**PLEASANT PRAIRIE PLAN COMMISSION MEETING
VILLAGE HALL AUDITORIUM
9915 39th AVENUE
PLEASANT PRAIRIE, WISCONSIN
6:00 P.M.
MARCH 9, 2015**

- A. Consider the request of Peter Kucha, of Eppstein Uhen Architects, Inc., agent for Uline for approval of **Preliminary Site and Operational Plans** for mass grading and preliminary approval of an office building and site improvements for a Uline Headquarters Office building (H2) generally located at the 11200 block of 120th Avenue (West Frontage Road).

Consider the request of Peter Kucha, of Eppstein Uhen Architects, Inc., agent for Uline for approval of **Preliminary Site and Operational Plans** for mass grading and preliminary approval of an office building and site improvements for a Uline Headquarters Office building (H2) generally located at the 11200 block of 120th Avenue (West Frontage Road).

ONSITE CIVIL ENGINEERING INFRASTRUCTURE PLANS

SHEET C-9 OF C-14

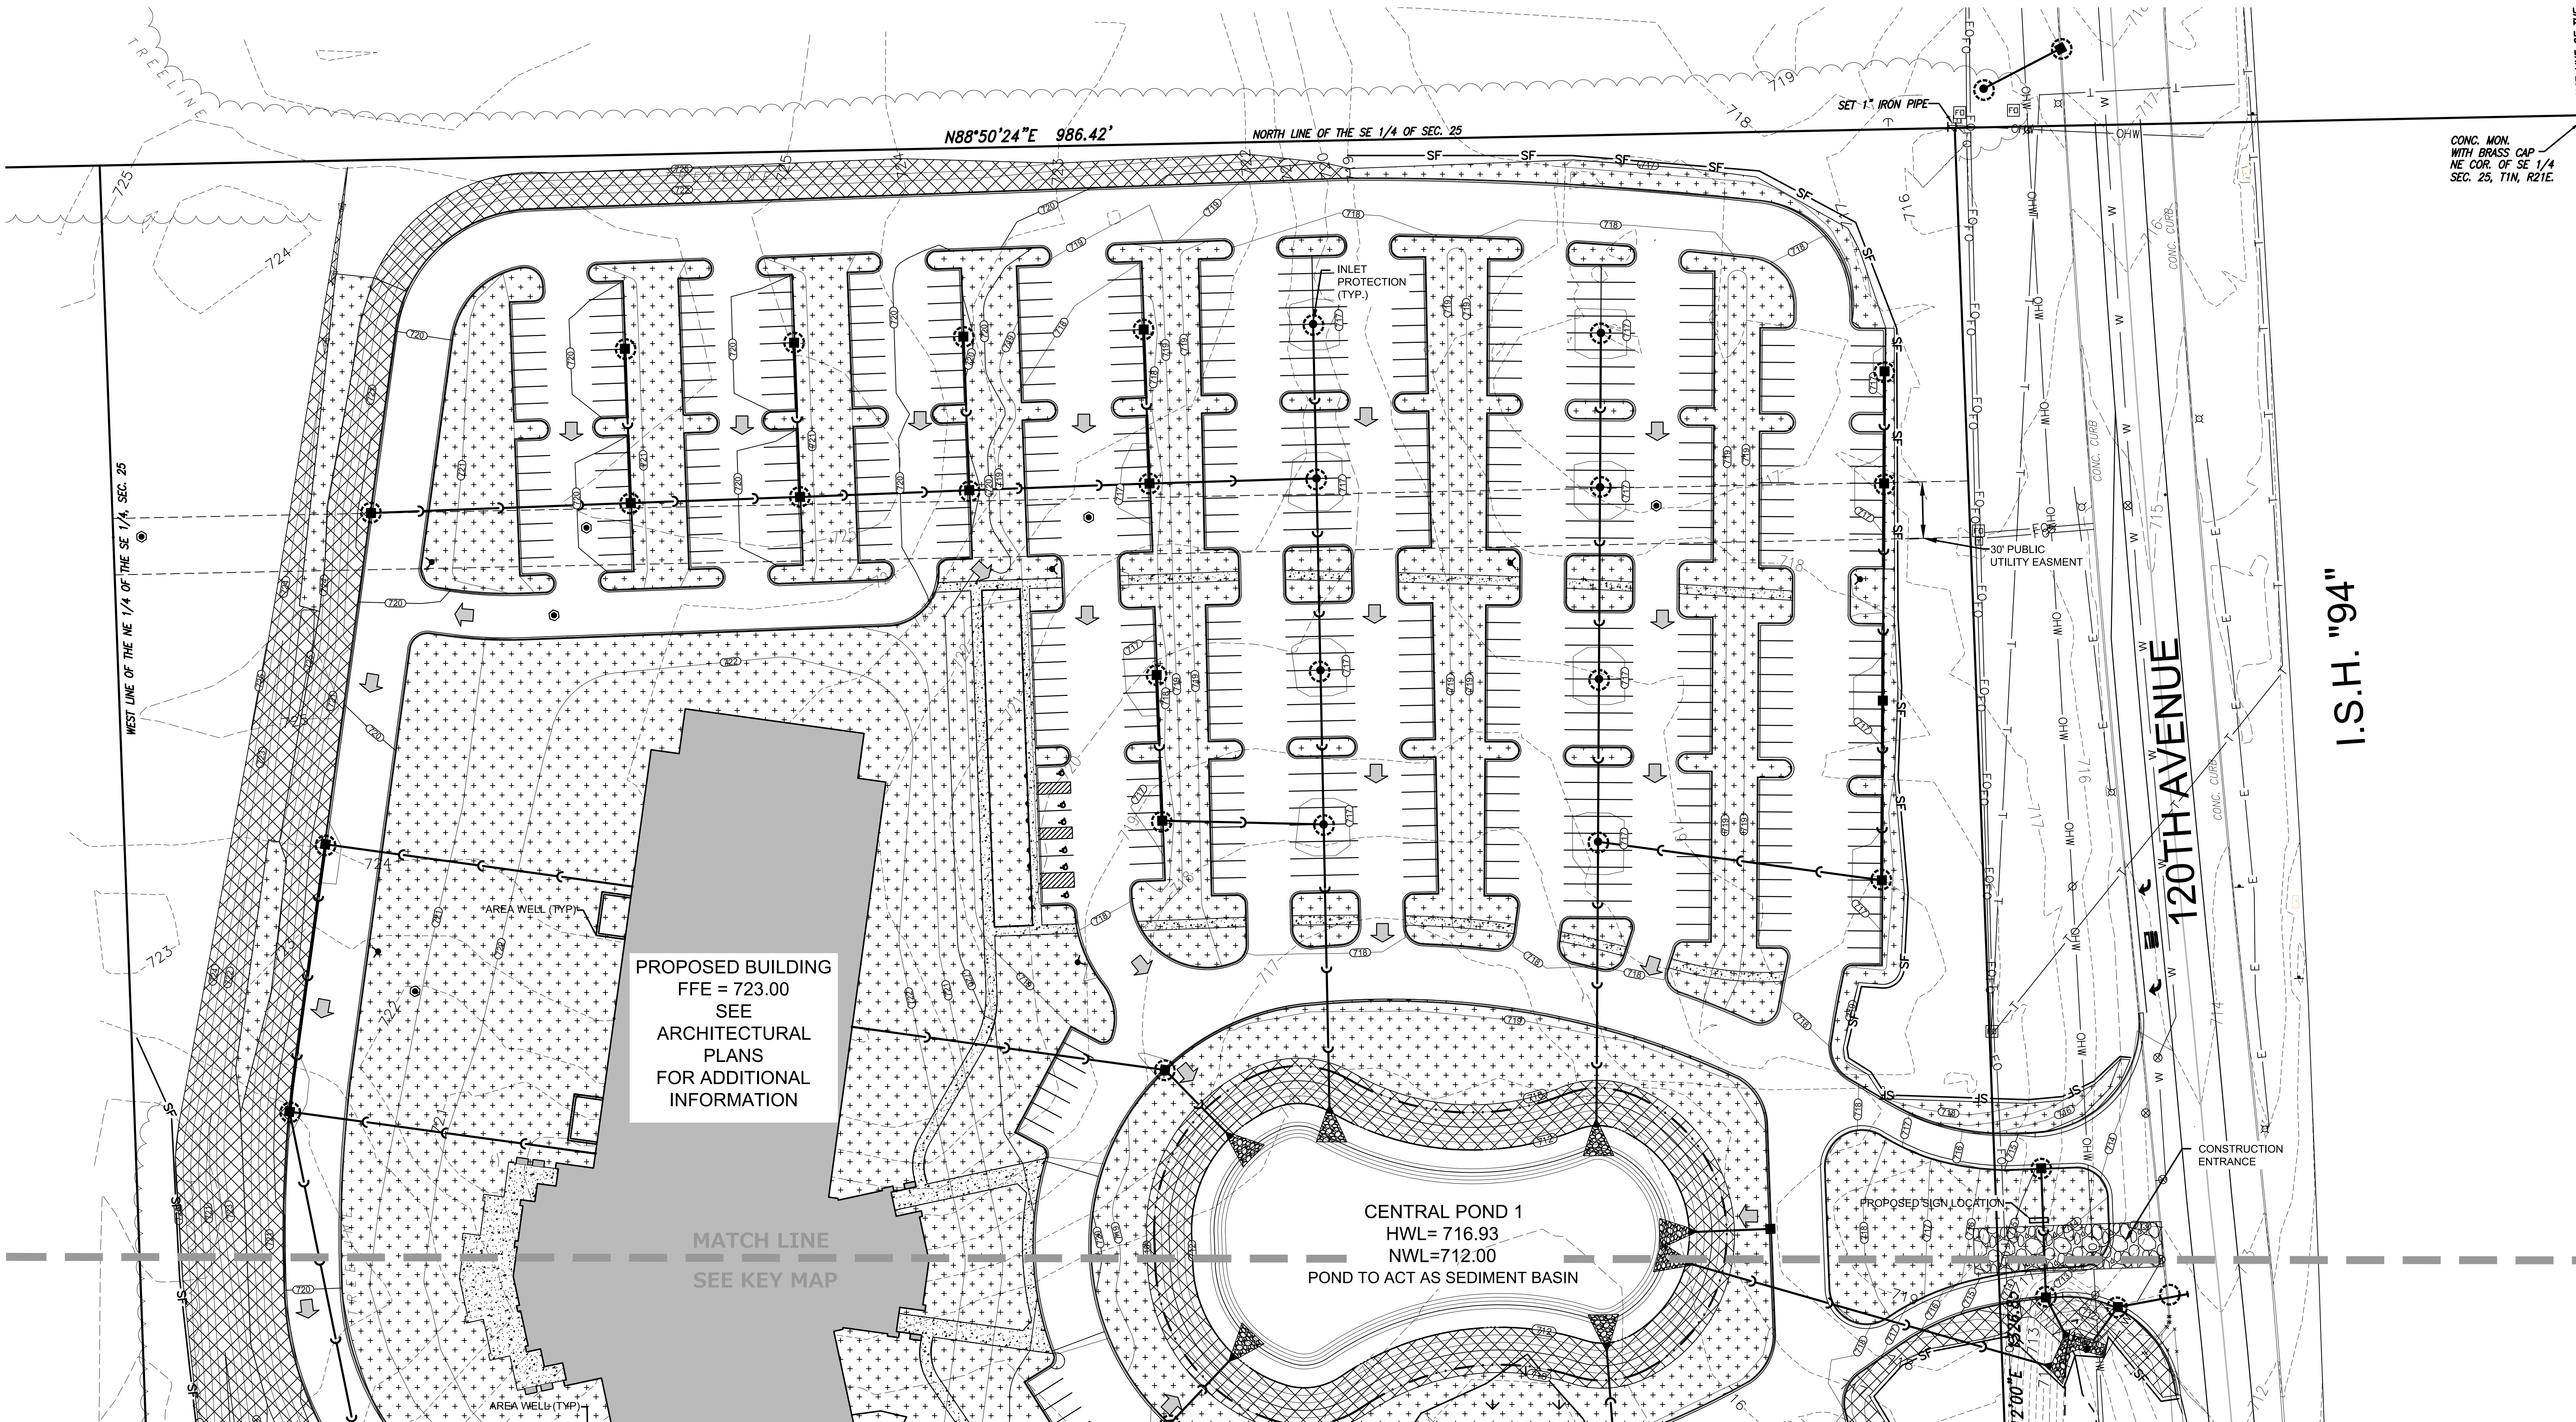
- (13) Label the size of existing public utilities on the plans.
- v. Site Stabilization Plan (Sheets C-9 & C-10):
 - (1) Label the rip rap size on the plans.

- (2) Over excavate the pond used for sediment control during construction or add a note to remove sediment to design grade near project completion.
- vi. Construction Details (Sheets C-11 to C-14):

WEST ELEVATION A SCALE: 1/16" = 1'-0"

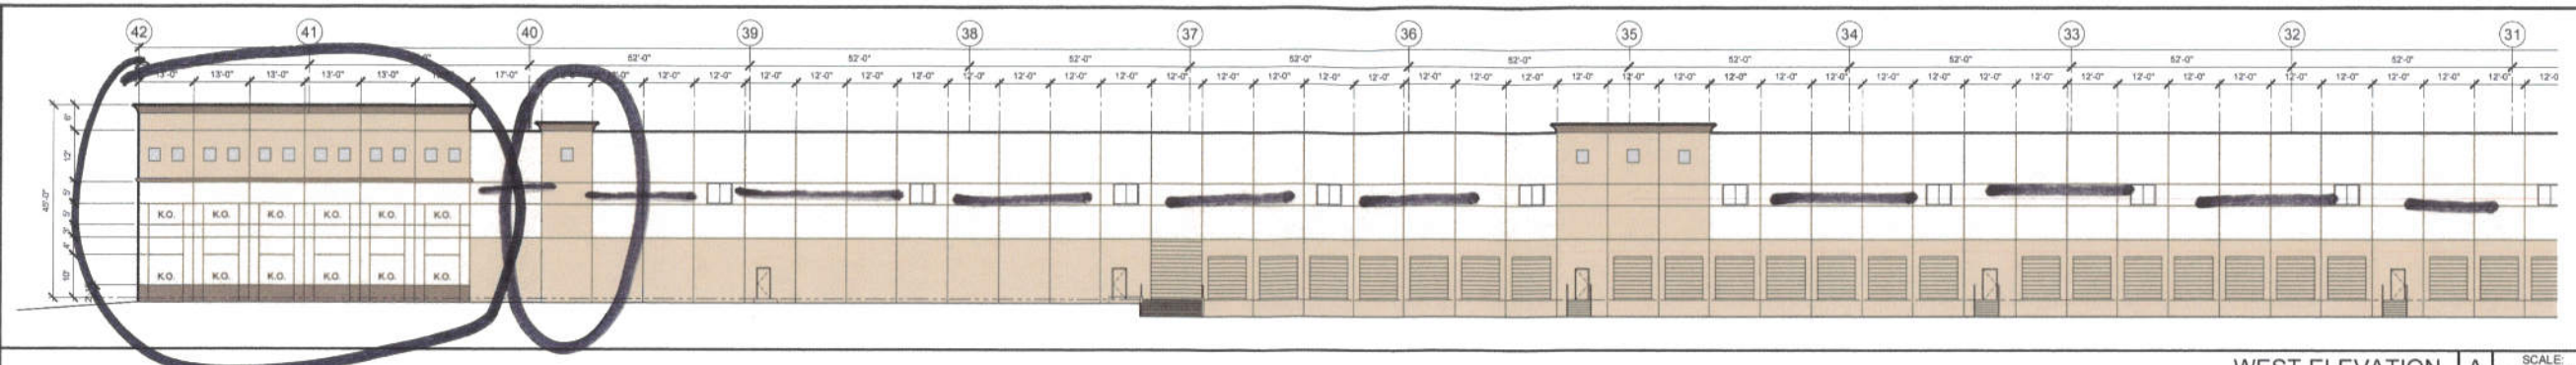
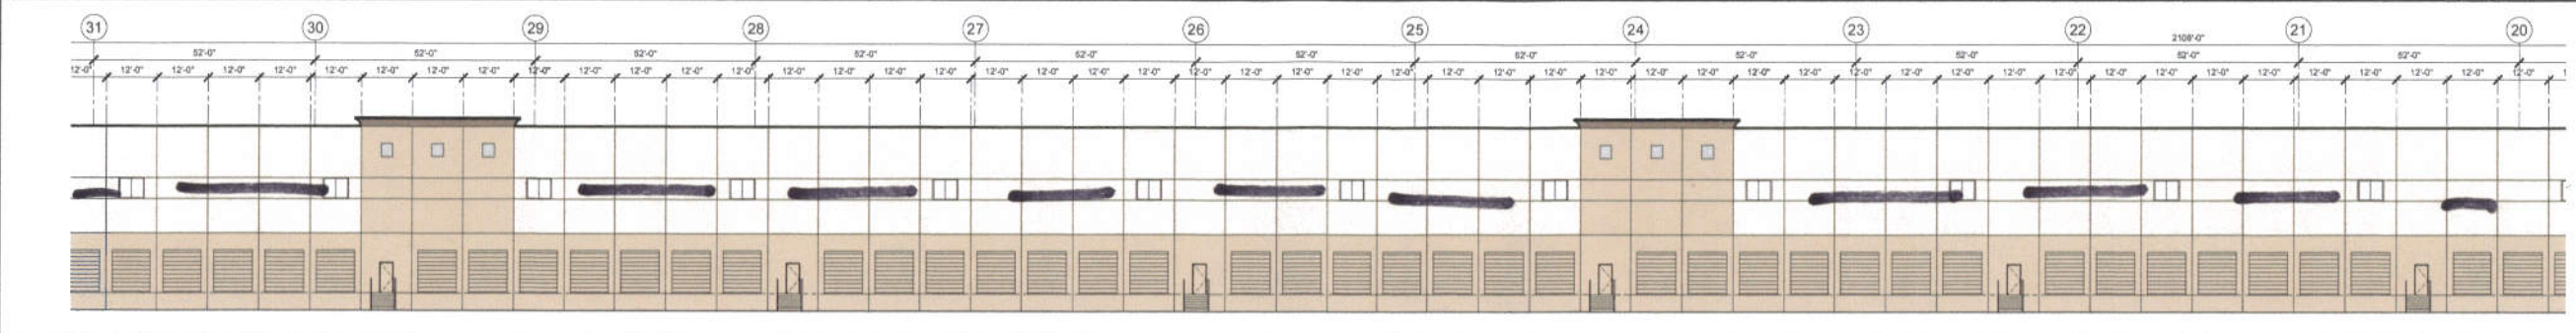
(cannot be flat)

Need to be bumped out to show articulation
